# Memorandum

From: Andy Paddock, P.E. , URS Structural Engineer

Subject: **Eaton Sugar Beet Factory, Structural Recommendations**

# FOURTH FLOOR PLAN

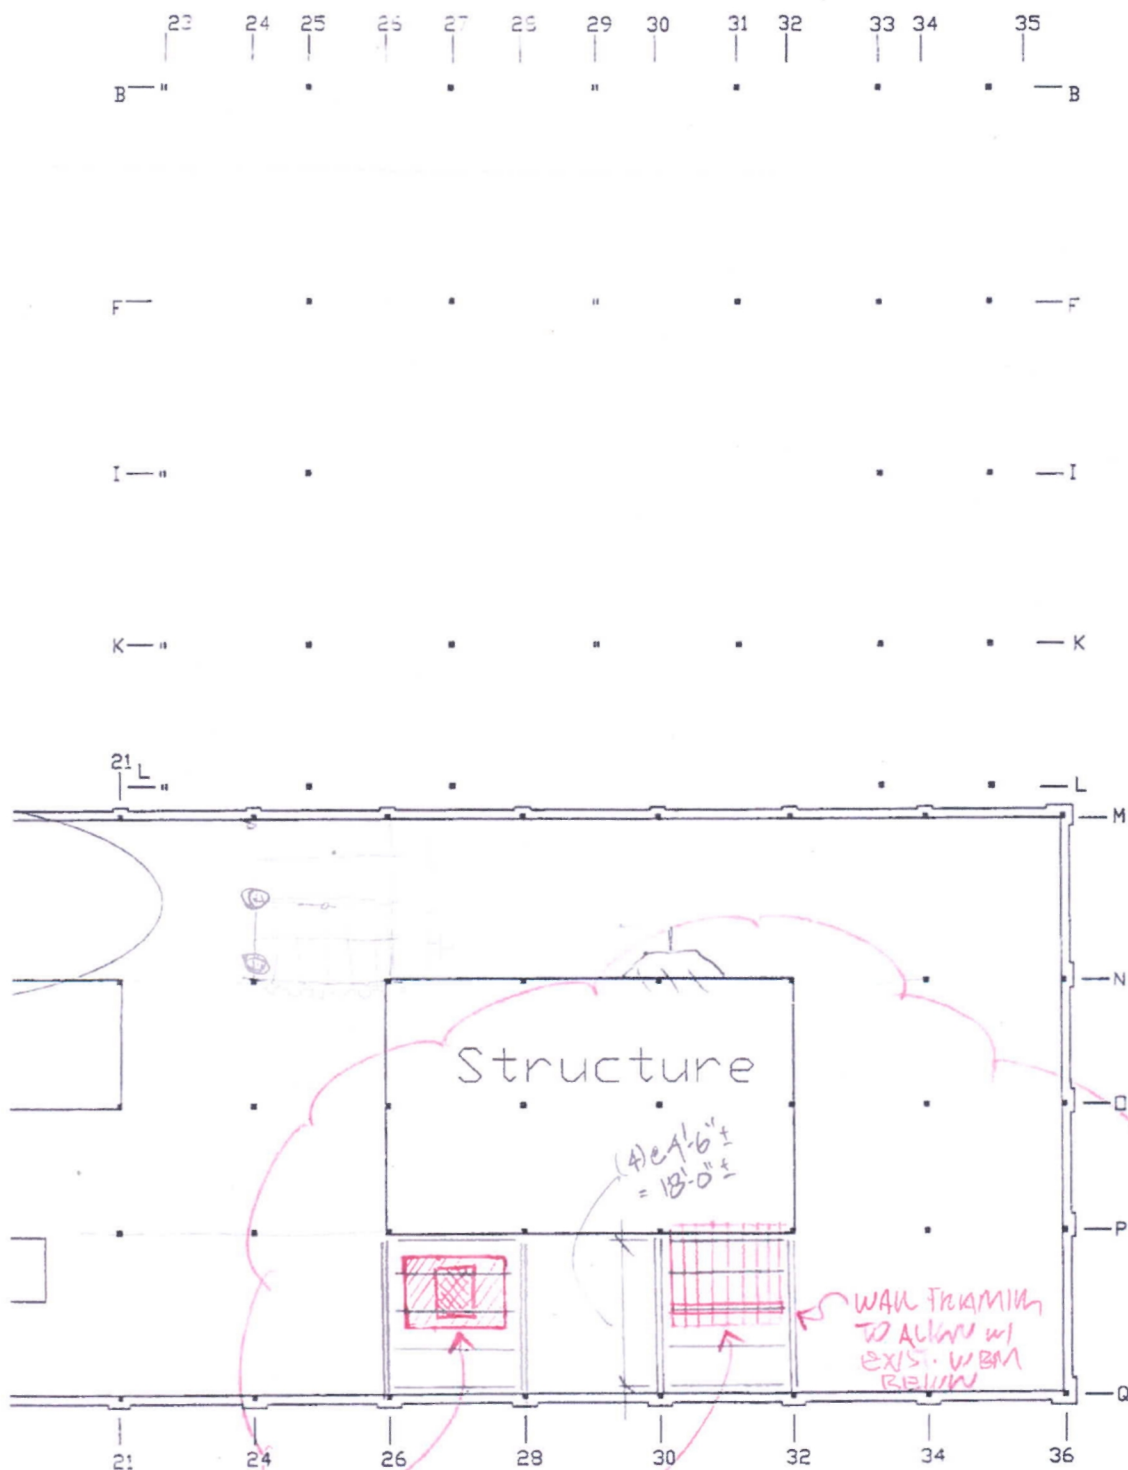
- Typical bays of existing roof are nominally 14' wide x 18' long and consist of two (2) 18' long girders which support five (5) 14' long roof beams.
- The approximate capacity of these existing steel roof beams was checked and they appear to be capable of supporting the estimated construction load of between 2,000 to 3,000 pounds, when uniformly distributed over an area 14' wide and 10' long.
- Load testing should occur at each of these typical roof framing "bays" and should uniformly apply the anticipated construction load over at least two (2) of the three (3) steel roof beams expected to support the temporary access platforms.
- Load testing durations should be on the order of 30 seconds to a minute for each bay with careful attention being paid by the crane operator to the slack or tension applied to the cable during testing as this will be an indicator of the roofs capacity.

- The new temporary access platform framing should follow standard wood framing convention and use Hem Fir No 2 or better lumber. Roof joists = 2x6 @ 24" o.c., wall studs = 2x6 @ 24" o.c. or 2x4 @ 16" o.c., floor joists = 2x6 @ 24" o.c. or 2x4 @ 16" o.c. wall, and roof sheathing shall be at least 7/16" OSB and floor sheathing shall be 23/32" OSB if joists are 24" o.c. or 5/8" if joists are 16" o.c.
- Uplift connections between existing steel roof framing and the new access platform could consist of either 3/16" diameter cable or Simpson CS22 coil strap through 3/8" diameter holes in the center of the floor joists, through the existing wood roof decking and wrap around the existing steel roof framing. These connections, or equivalent connections, should occur at each steel beam at 48" o.c.

See the attached sketch for a graphical depiction of the general framing configurations referenced above.
